RE: S/D 96-60, Final Plat of the NORTHRIDGE ESTATES ADDITION

At the regular meeting of the Subdivision Committee of the Metropolitan Area Planning Commission on Thursday, November 21, 1996, the above captioned plat was considered. The action of the Committee was to recommend that this plat be approved subject to:

CASE NUMBER: S/D 96-60 - NORTHRIDGE ESTATES ADDITION

NORTHDRIDGE ESTATES

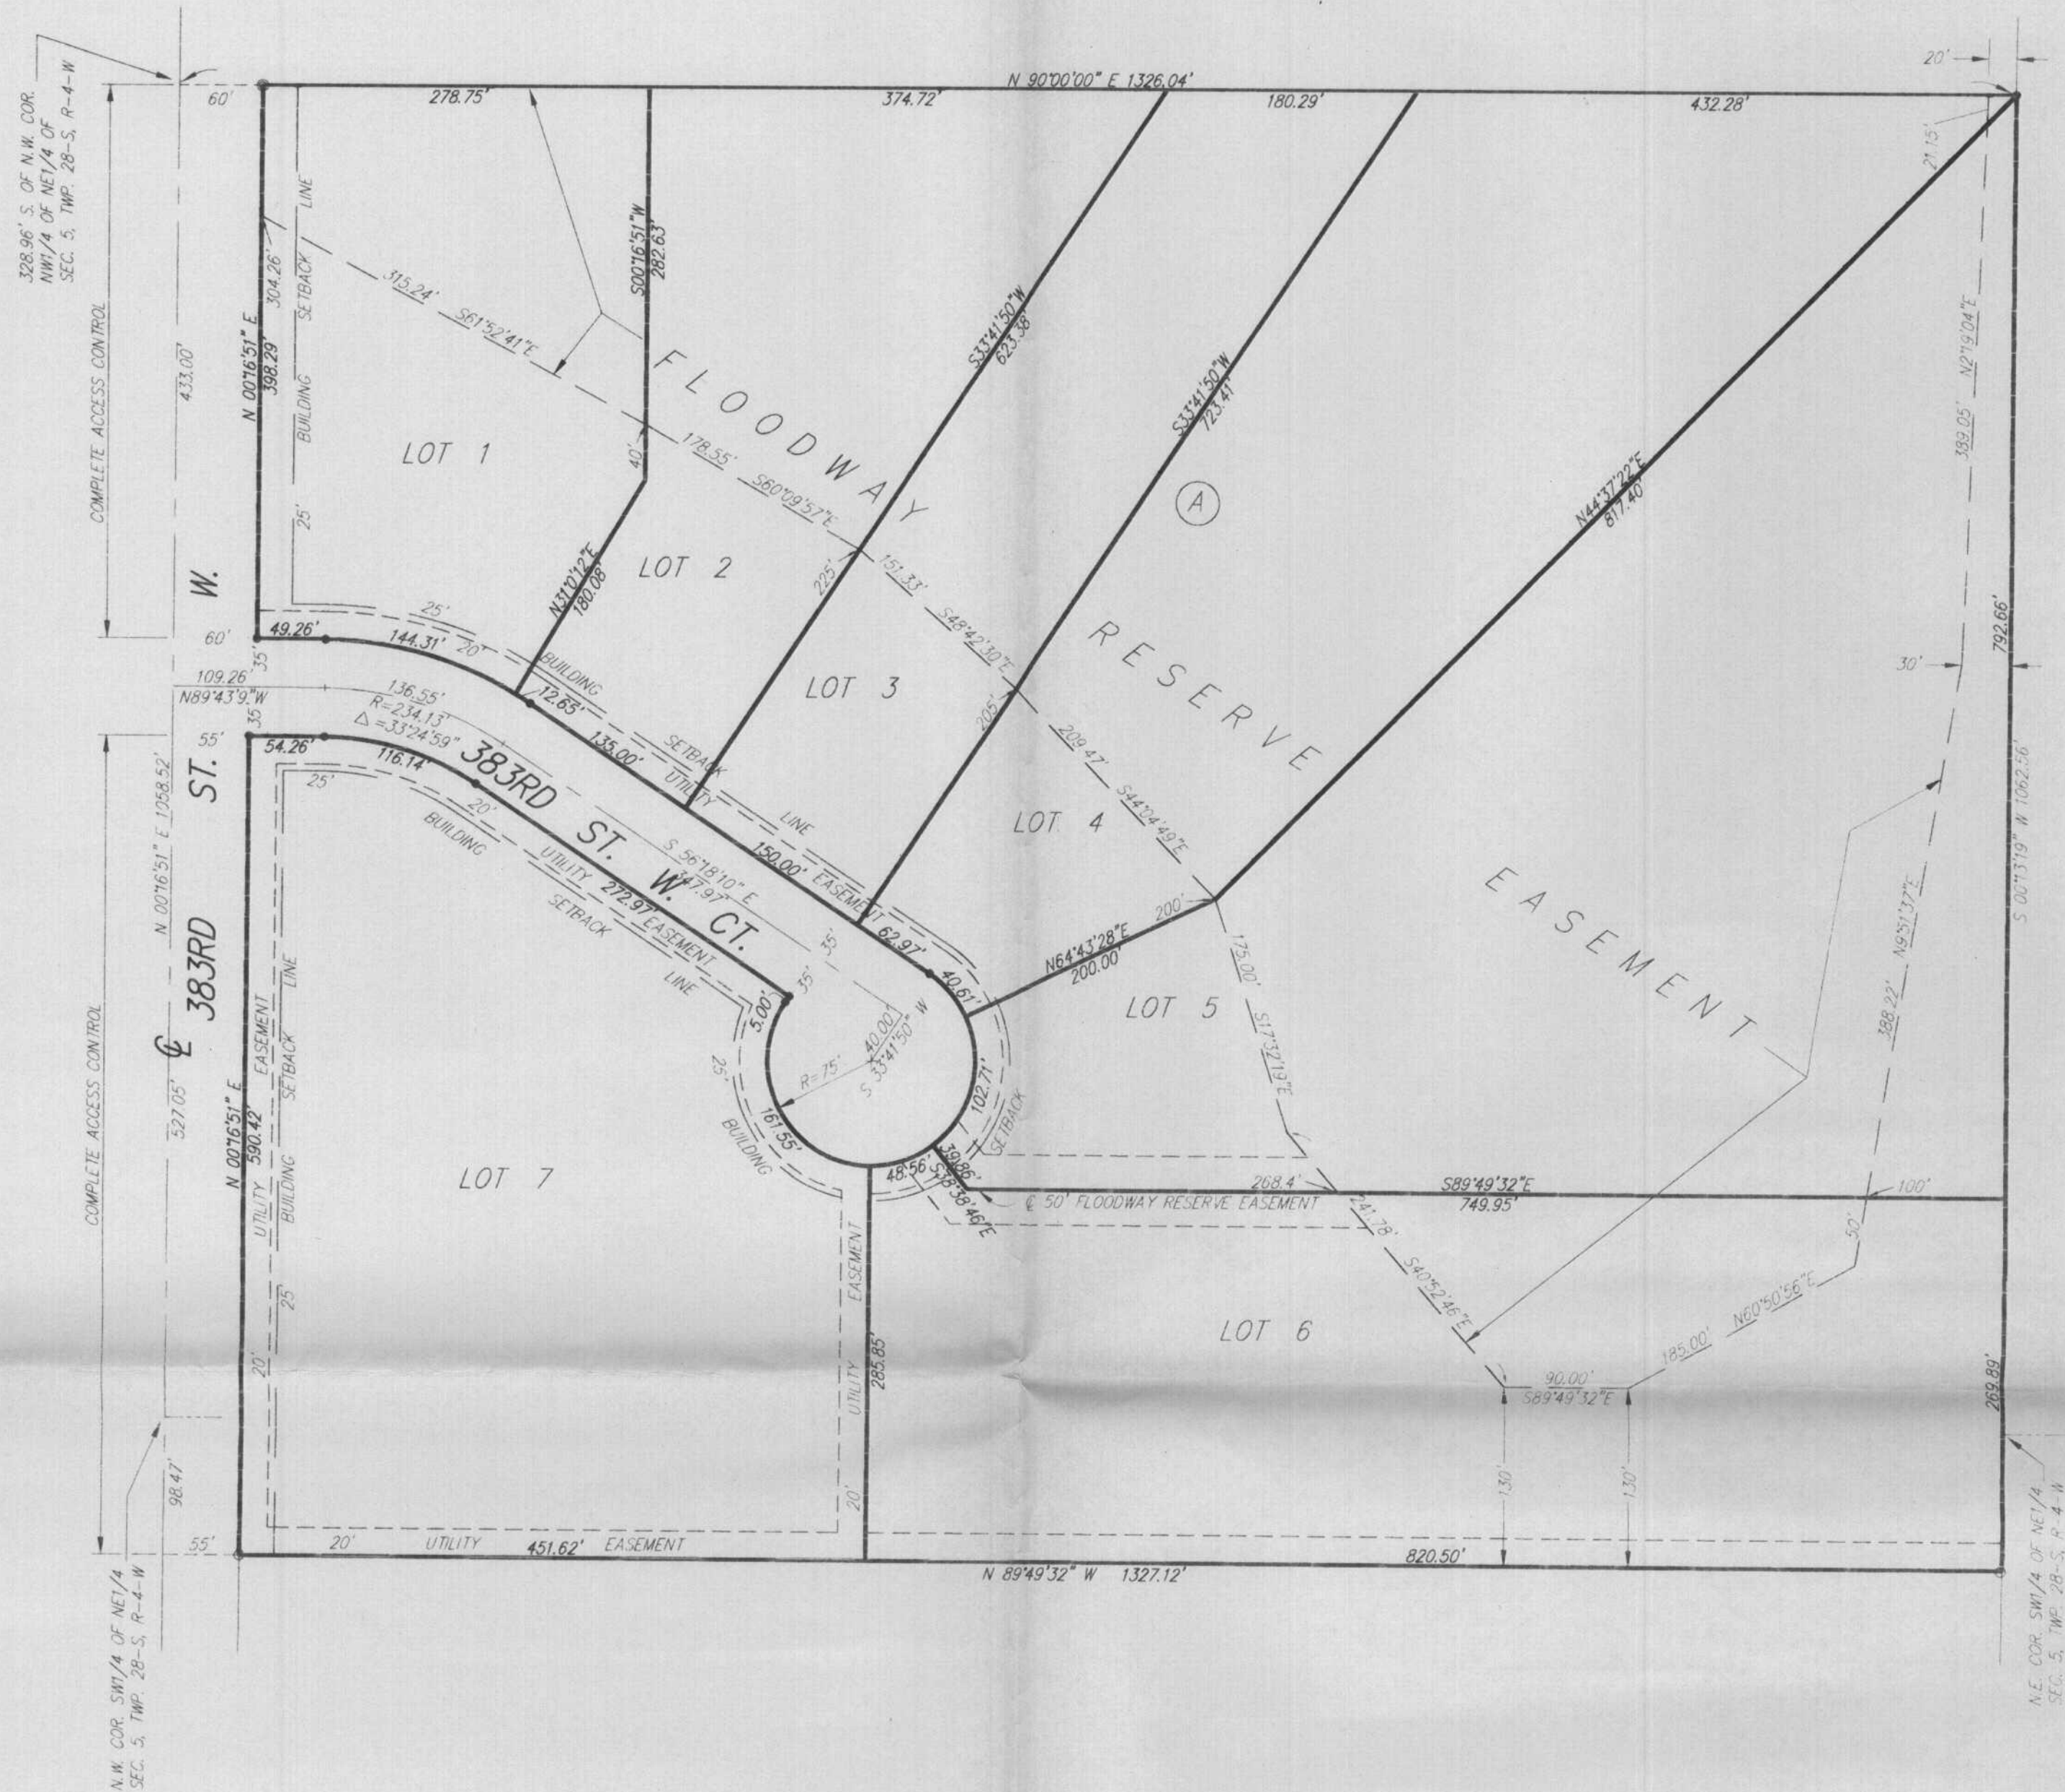
However, Lots 7 and 8 shall be combined into one lot with either septic or lagoon sanitary sewer used if allowed by the Health Department. For the other lots of this plat, because of limited usable area, a covenant as required by the Health Department shall be provided for recording which clearly specifies that restrictions are involved for the location of homes, related uses and on-site sanitary sewer for these lots. This covenant shall also

D. During review of the preliminary plat, it was stated and approved that since Cheney Spur is a major north-south street connecting U.S. 54 and Cheney, all lots adjacent to that street shall be platted with complete access control. Also that a guarantee shall, therefore, be provided to close the opening shown at the southwest corner of Lot 7.

However, this final plat is continuing to show an access opening to 383rd Street West from Lot 7. At this time, apparently, an existing use on what is being platted as Lot 6, has driveway access out to 383rd Street West. Also, a use to the south appears to be using this opening for access. The plat is indicating a 40-foot easement to the interior cul-de-sac, which would apparently be to the benefit of the use south of the site. Also, the uses on Lot 6 would be expected to use the interior street when it is constructed. Consequently, the opening to 383rd Street West, appears to be a temporary need until such time as the interior street is constructed.

not shown
F. The 40-foot ingress and egress easement along the west line of Lot 6, if created by separate instrument, needs to have indicated the recording information for the easement on the plat. Unless this easement is for a public purpose, its creation (as a private type easement) through platting is not appropriate.

- O. As noted by County Engineering during the Subdivision Meeting of November 7, 1996, the term "Easement" needs to be deleted from the area shown as a "Floodway Reserve" on the face of the plat. Also, the plat's text shall be amended to delete reference to an easement when associated with the Floodway Reserve. Further, Lots 3, 4, 5 and 6 shall indicate a minimum building pad elevation of 1364'.

Therefore, the opening from Lot 7 only be allowed as temporary access. A contingent dedication of complete access control by separate instrument shall be provided and words to that effect shall be placed in the plat's text. The contingency itself stating that complete access control to 383rd Street West from Lot 7 will occur when 383rd Street West Ct. is constructed.
